# Access Compliance Report

## Public Rights-of-Way

Intersection ID: 53096	Main Street: BRODIE LN	Cross Street: DIXIE RIVER RD	Location: SW
ADA ID: 23C331F4AC81	Ramp Type: BlendTrans1	Initial Pass/Fail: Fail	Overall Compliance: No
		Severity Score: 10

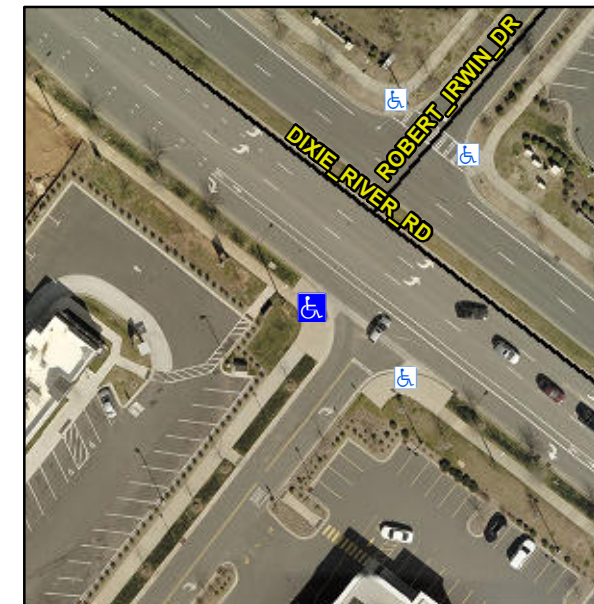
**MEDIAN ACROSS DIXIE RIVER RD**

**Not Found, R304.5.1, R304.5.3**

**Remove & Replace Curb Ramp With Two New Directional Ramps or Equivalent.**
